2B	Reviewed. Comments enclosed. Incorporate the comments and re-submit for review.

TYPE 05

SINGLE SLIDING GATE

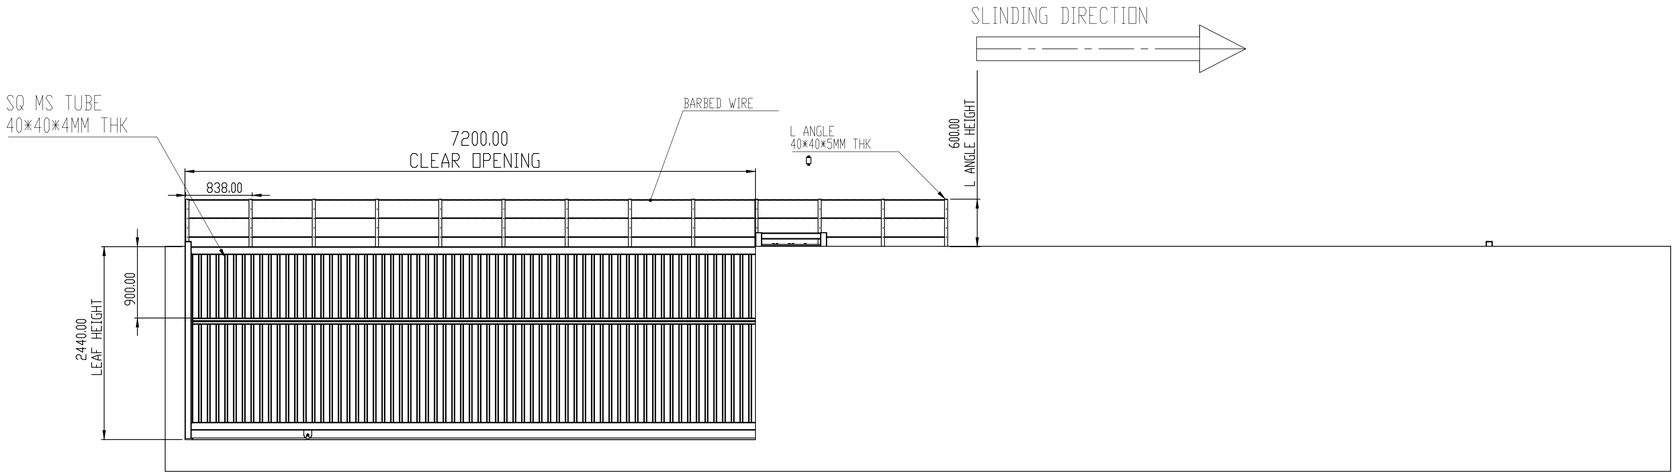
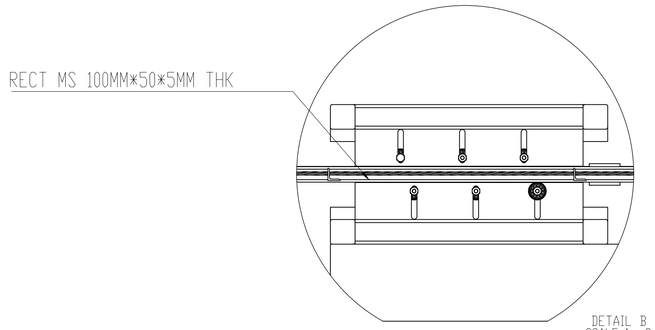
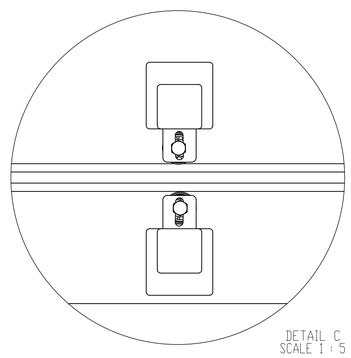
1. Please refer to the latest master layout for the exact site dimensions and space availability.
2. Barbed wire fencing above the sliding gate is under finalization with the Air India team. TCE will confirm shortly.
3. Please specify whether the elevation view is from the inside or outside. It is currently unclear.
4. As the door sizes are as per the requirement, kindly consider the weight and design the sections accordingly.
   Also, the wheel should be a double wheel, as shown in the architectural layout.
   Locking arrangement details are missing from the GA drawing.
